TECHNICAL EVALUATION REPORT
REVIEW OF TOPICAL REPORT GENE-770-06-1
"BASES FOR CHANGES TO SURVEILLANCE TEST INTERVALS AND ALLOWED
OUT-OF-SERVICE TIMES FOR SELECTED INSTRUMENTATION TECHNICAL SPECIFICATIONS"

Don R. Lasher

Idaho National Engineering Laboratory
EG&G Idaho, Inc.
Idaho Falls, Idaho 83415

Prepared for the
U.S. Nuclear Regulatory Commission
Washington, D.C. 20555
Under DOE Contract No. DE-AC07-76ID01570
FIN No. D6045

QUESTION 3 - ATWS-RPT LOGIC

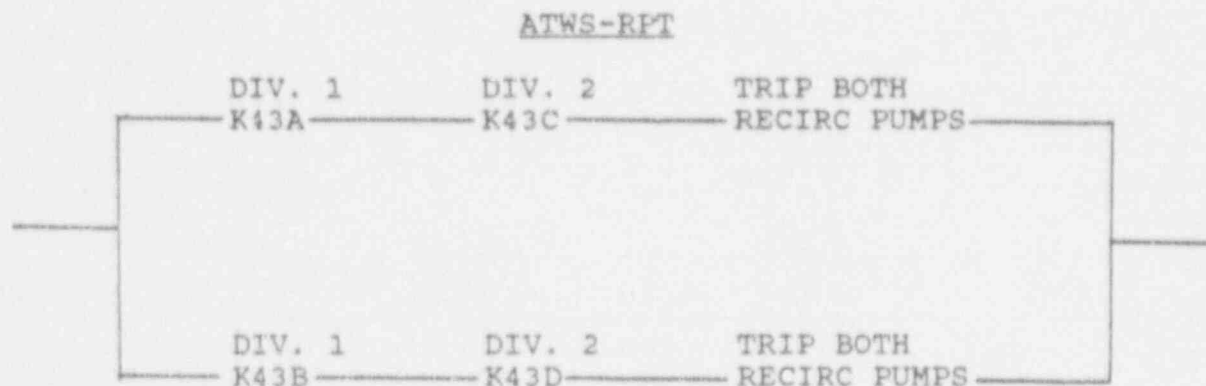
We did not agree on the ATWS-RPT logic for the BWR4 Improved Standard Technical Specifications (ISTS) Lead Plant (Hatch 2) which is given in the

topical report as one-out-of-two per trip system with the tripping of both trip systems needed to trip both recirculation pumps. Our logic diagram as obtained from the Hatch 2 UFSAR showed a two-out-of-two logic per trip system on either high reactor pressure or low reactor vessel water level and trip of either trip system trips both pumps. After discussion with G.E., it appears that the newer BWR4 ATWS-RPT logic arrangement and that which is or will be installed on most BWR4 plants is the logic arrangement from the Hatch 2 UFSAR. The Hatch 1 plant was stated to have been modified to this newer design at the last outage and the utility indicated that Hatch 2 (the lead ISTS plant) will be so modified during the upcoming outage. This newer information should be made part of the topical report.

The topical report states that the effect of changes to STI and AOTs for ATWS-RPT instrumentation on the reactivity shutdown failure frequency is negligible because the RPS failure frequency is low ($5.4\text{E-}06/\text{yr}$ from NEDC 30851P, page 5-29) and the change in overall ATWS-RPT function unavailability due to the STI and AOT changes ($<1\text{E-}02/\text{demand}$) is small. This appears to say that even though the ATWS-RPT failure frequency may be higher, when it is combined with that for the RPS, the combined effect is small. It is not clear how this combination is made or how the numbers were calculated. Can you supply some additional information explaining how these numbers were arrived at and how they were combined with the RPS?

The last sentence on page 6 of the report seems to state that the same small change in ATWS-RPT unavailability due to STI and AOT changes can be expected for other logic designs. It is not clear how this can result since it would appear that the logic arrangement should have a large influence on the fault trees and their evaluation which means a change in the logic configuration could result in a large change in unavailability and hence failure frequency. This would indicate that the reliability of a system is nearly independent of its logical arrangement. Please clarify this concern.

It was stated in Reference 2 that the trip logic for ATWS-RPT for the Hatch2 lead ITS plant is one out of two channels per trip system for each trip function. Both trip systems are required to trip the two recirculation pumps. This was the configuration at the time of the analysis. The ATWS-RPT configuration that is being installed during the current Hatch-2 refueling outage has the same type logic as the BWR 6 lead plant.

The ATWS-RPT logic for the BWR 6 lead plant (currently being installed for the BWR 4 lead plant) is two out of two channels required to trip each trip system for each trip function (low water level and high reactor pressure). It was stated in Reference 2 that the change in unavailability when the surveillance interval is extended from 1 to 3 months is small ($<1\text{E-}02/\text{demand}$). Calculation of this unavailability change is presented in Enclosure 3. Unavailabilities are calculated using trip unit failure rates from original design analyses and failure rates that reflect more current operating experience. The calculated change in unavailabilities for each trip function is approximately $2\text{E-}03/\text{demand}$ based on failure rates from the original design analysis and $2\text{E-}04/\text{demand}$ based on failure rates reflecting current operating experience.

The relative effect of the ATWS-RPT unavailability change on the reactivity shutdown failure frequency is also shown in Enclosure 3. Assuming only one ATWS-RPT trip function (low water level or high reactor pressure) and the RPS failure frequencies calculated in Reference 3, the relative change in reactivity shutdown failure frequency when the ATWS-RPT channel functional test is extended from 1 to 3 months is negligible ($<2.0\text{E-}08/\text{year}$). This calculation does not include other ATWS-RPT components which are not part of the channel

Figure 2
LOW-LOW SET FAULT TREE FOR HATCH 2

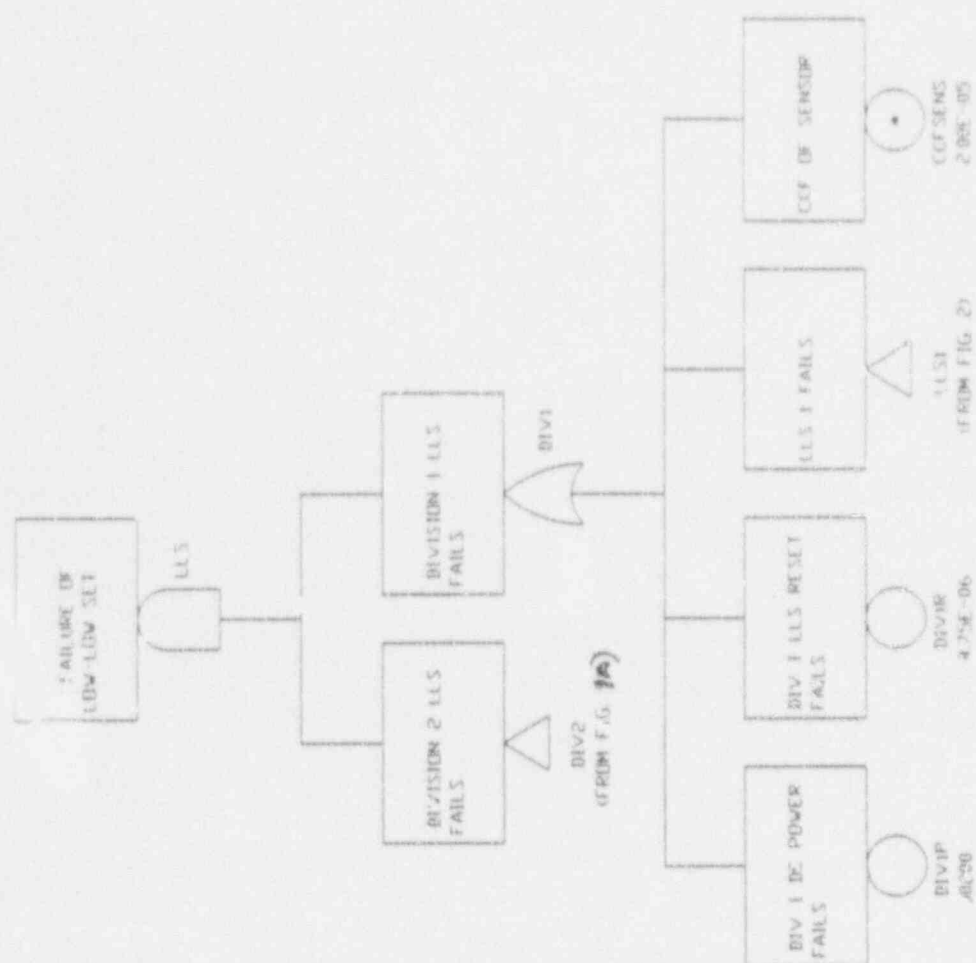
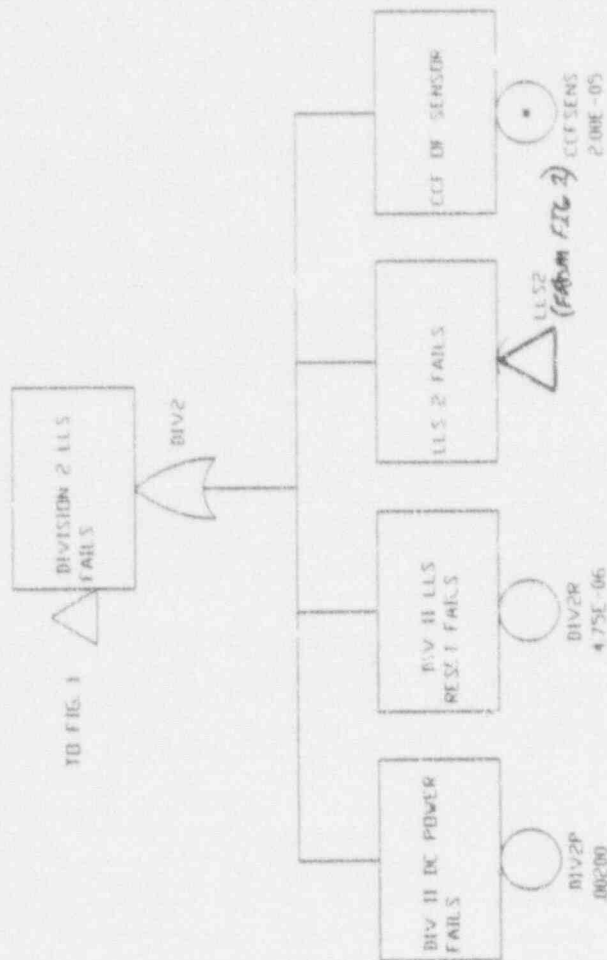
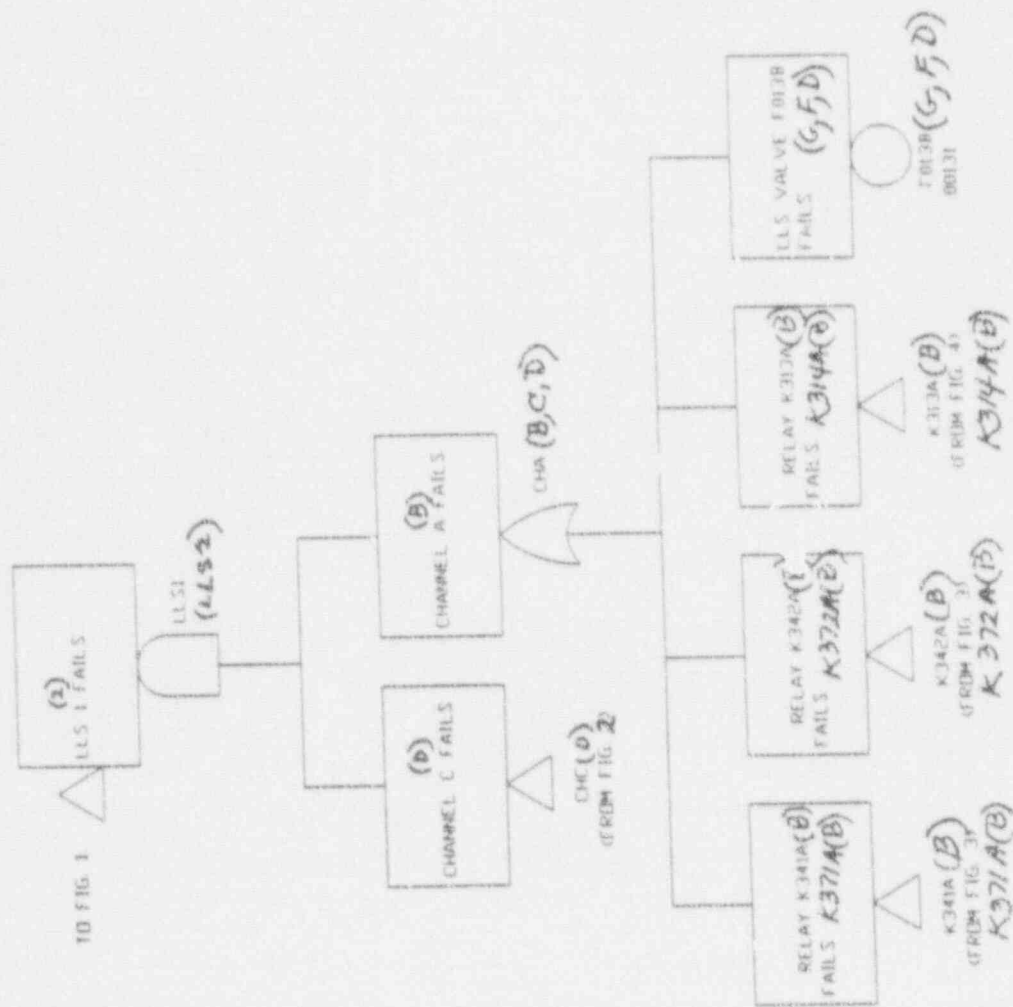
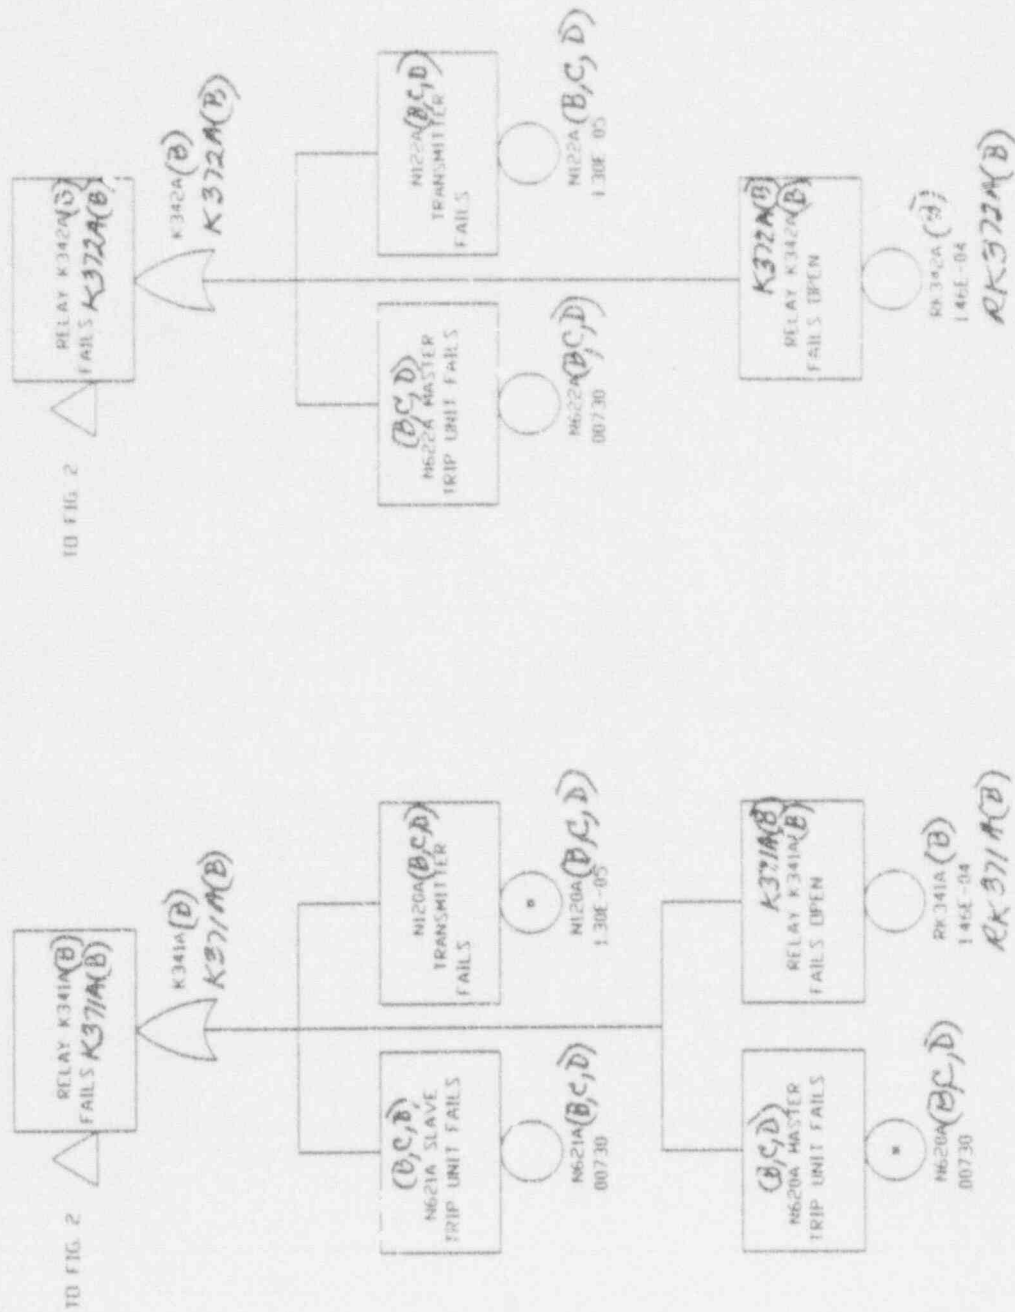
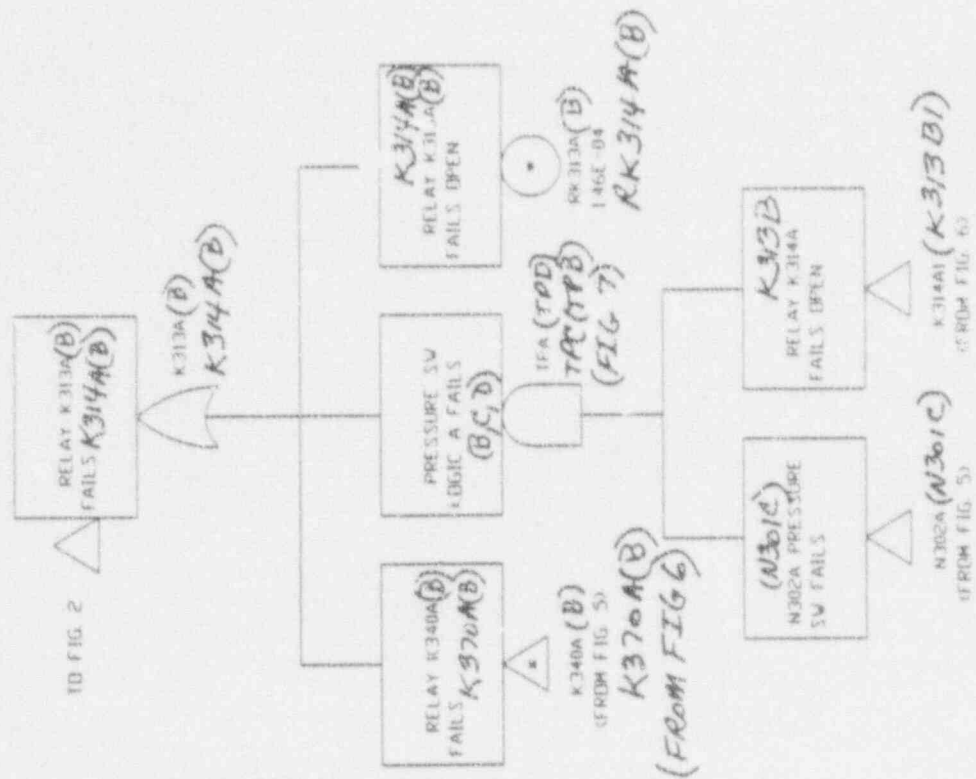
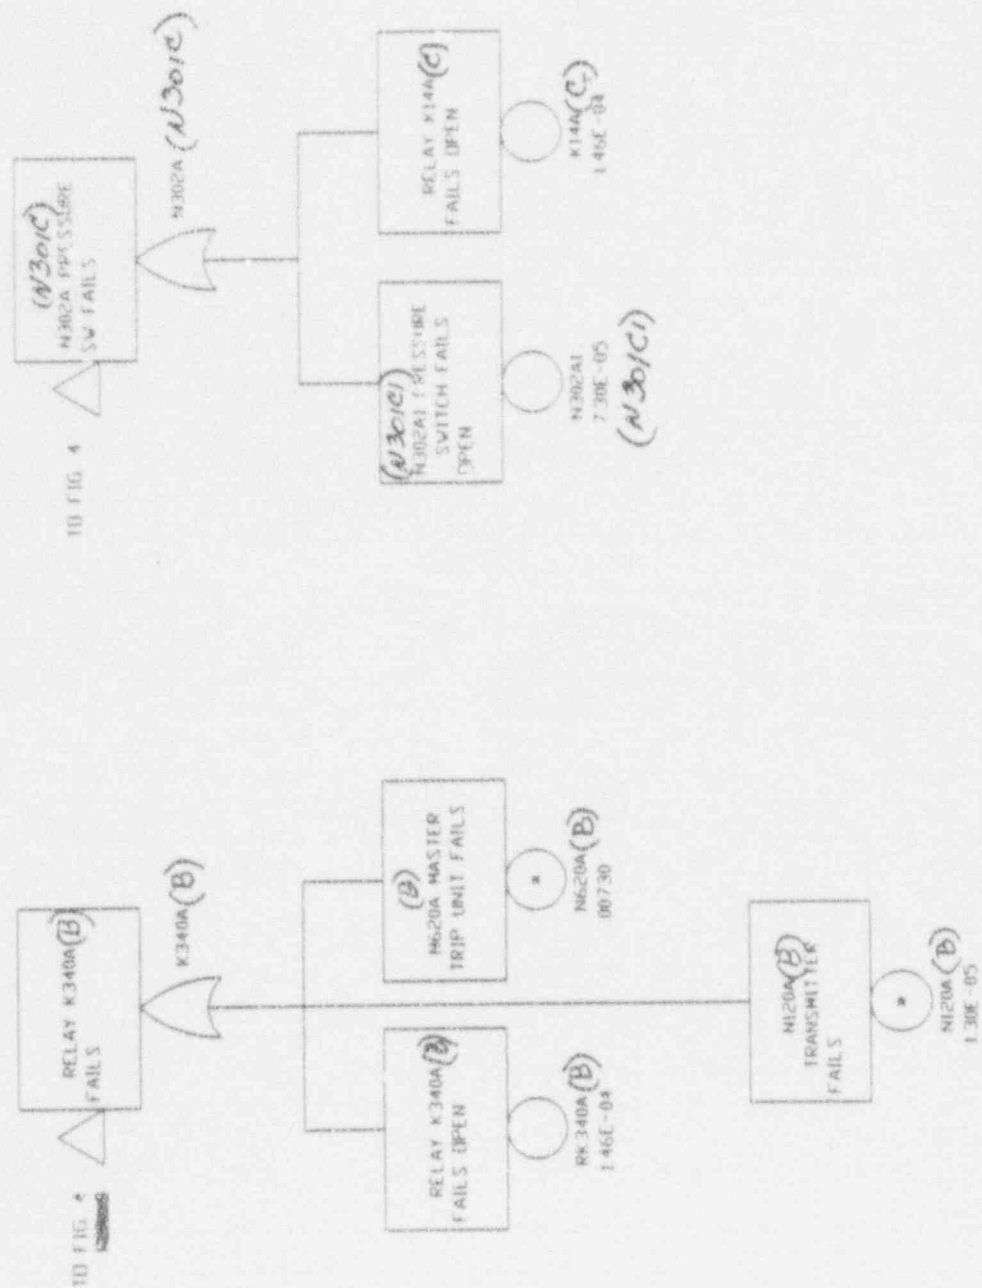
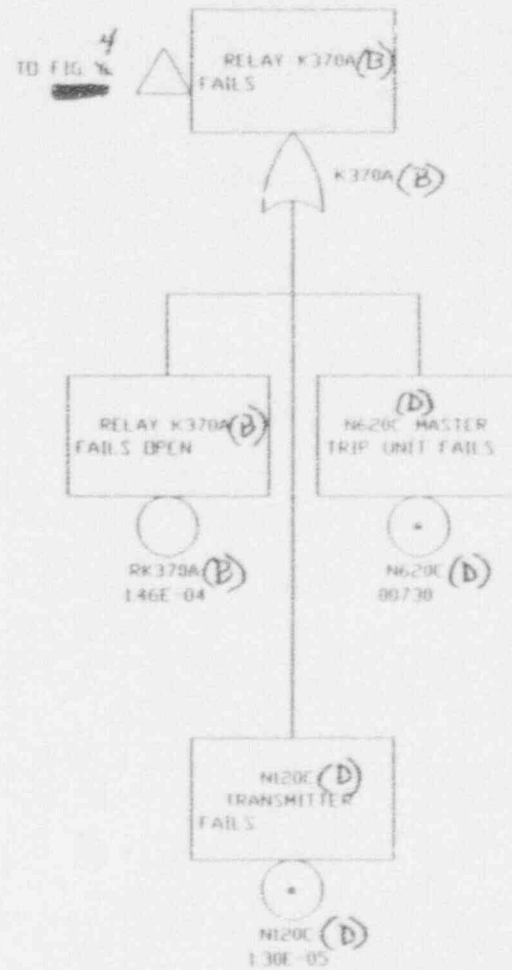
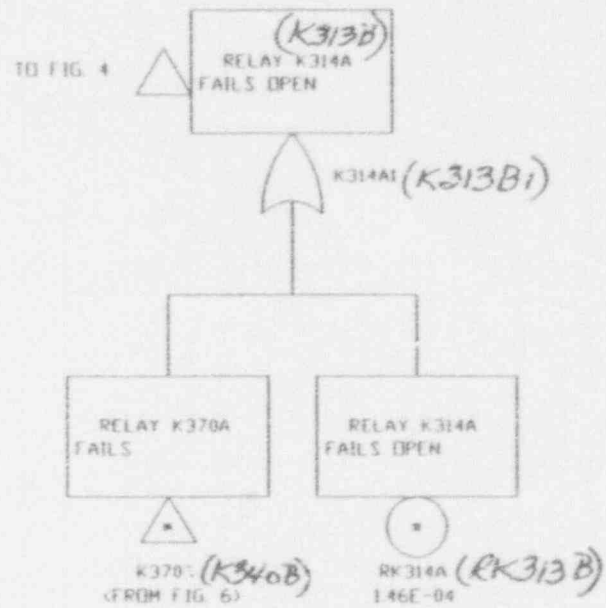
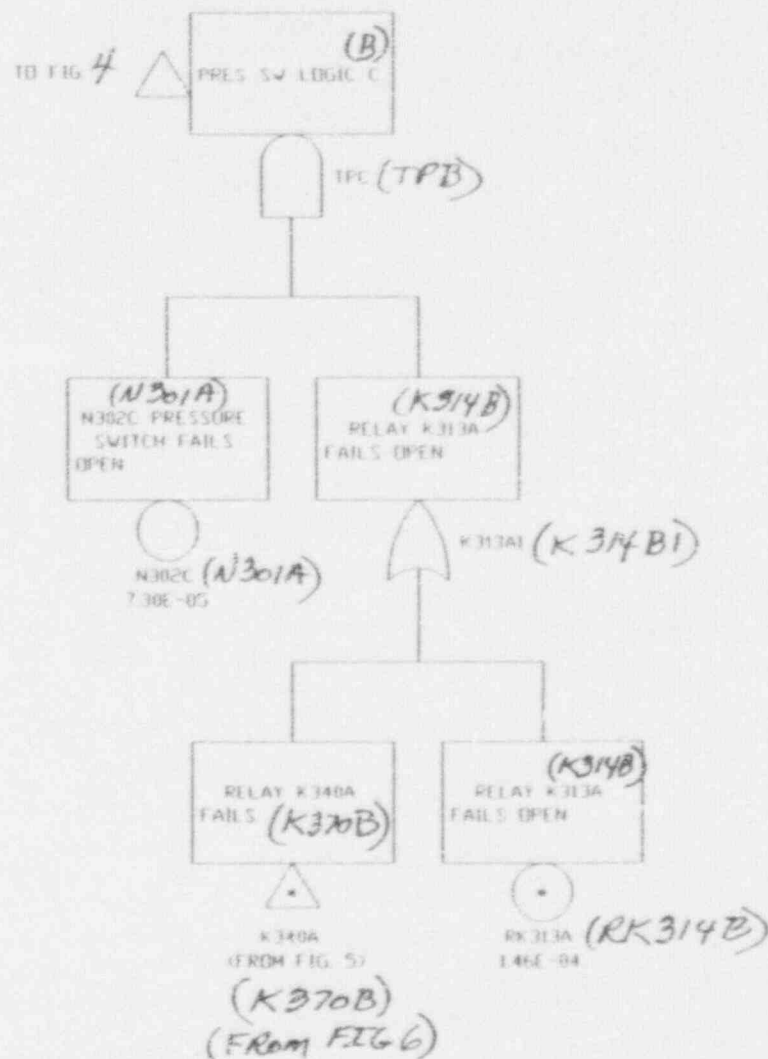
In response to our Question Four, the BWROG submitted additional information consisting of fault trees and evaluations for the BWR4 LLS logic. In our review of this information, we agree that four of the eleven S/RVs can be actuated by the LLS logic and that only one of the four needs to open to fulfill the LLS function. We did, however, question whether the channel logic used for the fault trees followed the channel logic as presented, for example, in the Hatch, Unit 2, BWR4 plant. Our review showed two LLS logic channels in each Division: Channels A&C for Division I and channels B&D for Division II with each channel actuating one of the four LLS valves as follows. A permissive relay receives a signal on reactor vessel high pressure from PT1(x)[N120(x)]. These relays are assigned as follows: Channel A-K340A, Channel C-K370A, Channel B-K340B and Channel D-K370B. The contacts of each such permissive relay are wired in series with the coil of the arming relay and the paralleled contacts of the tail pipe switches associated with that channel. The arming relays are: Channel A-K313A, Channel C-K314A, Channel B-K313B and Channel D-K314B. Actuation of an arming relay seals it in through a set of auxiliary contacts. Each of the 11 S/RV tailpipes is equipped with two pressure switches which senses actuation of the S/RV. One of these switches

Evaluation of the fault trees showed the change in unavailability due to the change in surveillance intervals from one to three months was 3.92×10^{-5} per demand which is relatively small. Because the change in unavailability is small, the changes in surveillance interval and allowed out-of-service times for testing are comparable to those for other similar systems, and failure of the LLS function does not have an immediate direct impact on plant safety, we conclude these changes are acceptable for this system.

For the BWR4 LLS function, it is stated that failure of the LLS function to initiate will not have an immediate adverse effect on the plant safety and therefore, that any small change in actuation instrumentation unavailability due to changes in the STI and AOTs may be neglected. However, the changes in the SRV LLS function actuation instrumentation unavailability caused by changes in the STI and AOTs have not been shown to be small enough to neglect. The argument is made that the reasoning which supports making the requested changes is bounded by the analyses performed for the ECCS and isolation actuation instrumentation and further that the analyses apply because the components used in the systems are the same or similar and the number of failures needed to disable the system are comparable. This argument as presented is unacceptable because it appears to fail to consider the manner in which those components are assembled into the LLS logic. For example, the LLS logic is an armed logic which is not similar to any of the ECCS or isolation actuation logic. Some of the subsystems may be similar but the manner in which they are organized into the logic is different, therefore the fault trees and their evaluation may differ and the results may not be bounded by the previous analyses. This has not been shown and neither has it been shown that the number and type of failures needed to disable the LLS actuation instrumentation is comparable to that for an identified previously reviewed ECCS or isolation actuation system. The topical report should be revised to demonstrate the similarity of this logic system to a specific reference logic system or systems.

Enclosure 4 provides a fault tree of the low-low set (LLS) for the Hatch 2 plant. There are 11 safety/relief valves (S/RVs) at the Hatch 2 plant. Four of these are actuated by the LLS. Failure of the LLS function requires failure of all 4 LLS valves. Each LLS valve is armed by a relay in a logic channel initiated by a high reactor pressure trip unit and one of the S/RV tail pipe pressure switches. Two of the valve arming logic channels receive trip signals from 5 tail pipe pressure switches. The remaining two arming logic channels receive trip signals from 6 tail pipe pressure switches. Each of the 11 S/RV tail pipes

A calculation of the LLS unavailability as a function of surveillance interval is given in Enclosure 4. Two LLS valves were assumed to open. The change in LLS unavailability when the surveillance interval is extended from 1 to 3 months is $3.92E-05/\text{demand}$. This change is acceptably low based on the function and failure consequences of the LLS (i.e., reduce the number of load cycles on the containment and S/RV discharge lines and reduce the number of S/RV actuations during the plant lifetime).
